**Caroline Owen - Objection: SSD5700-2012 Block 4S, Central Park, Chippendale**

Objection: SSD5700-2012 Block 4S, Central Park, Chippendale

We understand the proponent is seeking approval to amend the Concept Plan (MP 06_0171 Mod. 8) to excise the Block 4S from Blocks 4N and Block 1 and incorporate changes to the land use mix. Conversely, separate applications have been lodged for the approval of high-rise student accommodation for Block 4S (SSD 5700-2012) and changes to Blocks 4N and Block 1 (MP08-0253 Mod 4). This includes service vehicle access from Abercrombie Street (including a loading dock and drop off/pick up area for the childcare centre in Block 4N).

Diagram A: Proposed Block 4S in context of other large scale student housing blocks

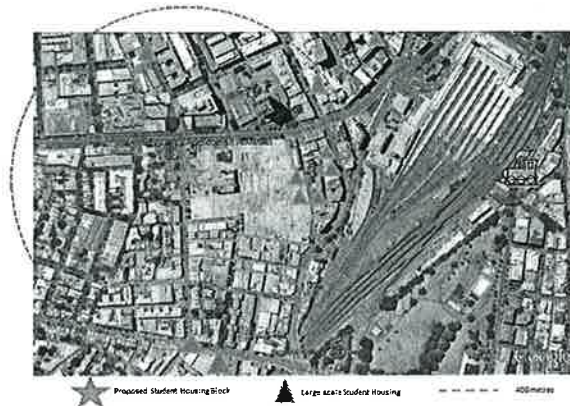
Further, the impact on local amenity as a consequence of students attending local universities needs to be considered. For example, the University of Notre Dame has expanded its operations from 380 students to about 4,000 FTE in the last few years without providing sufficient amenity or having a Master Plan; there has also been a substantive increase in the University of Technology's student population. Both universities are reliant on what little amenity there is in the area. This differs from the University of Sydney which has extensive open space on their grounds.
